To: NSW State Significant Development Assessment Panel

Subject: Objection – Proposed Development at 2 Fitzwilliam Street, Parramatta

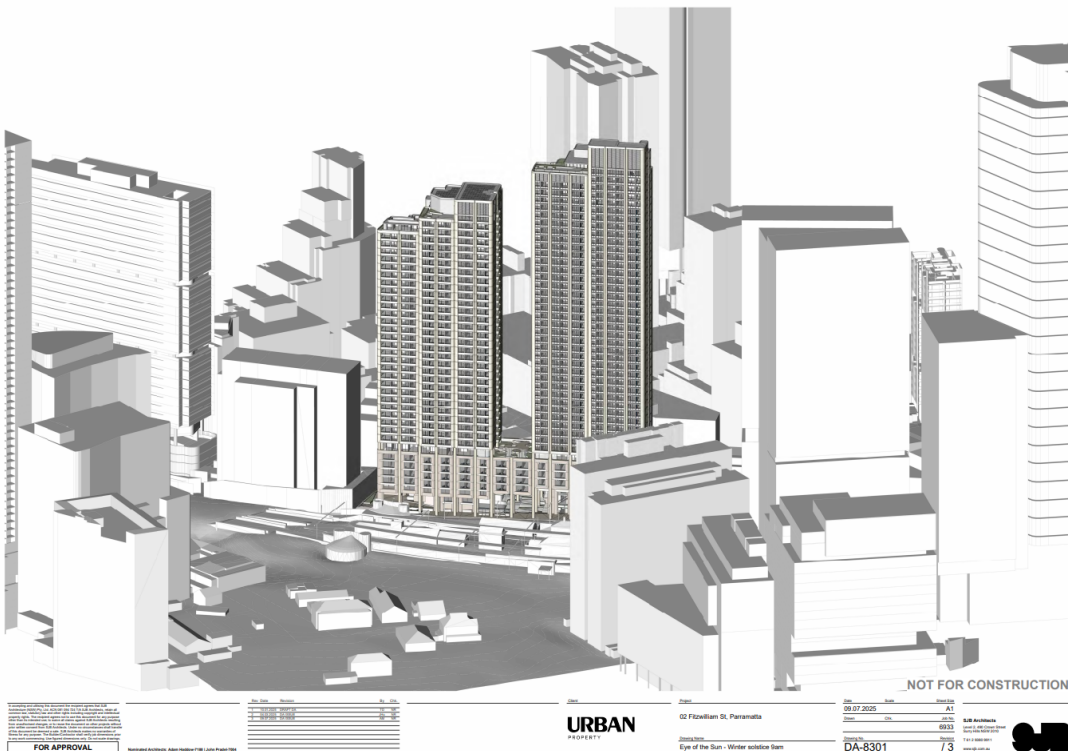
Although is a BTR project, the design fails to meet the minimum Apartment Design Guide (ADG) requirement that at least 70% of apartments receive two hours of direct sunlight to living areas between 9am and 3pm at midwinter. The proponent's own figures admit that only 64% of apartments achieve this, with **ALL south-facing units** receiving no adequate sunlight at all. Apartments on the southern façade will be particularly compromised, lacking balconies and directly overlooking neighbouring apartments at 110 Church Street and 88 Church Street, creating both privacy intrusions and amenity loss.
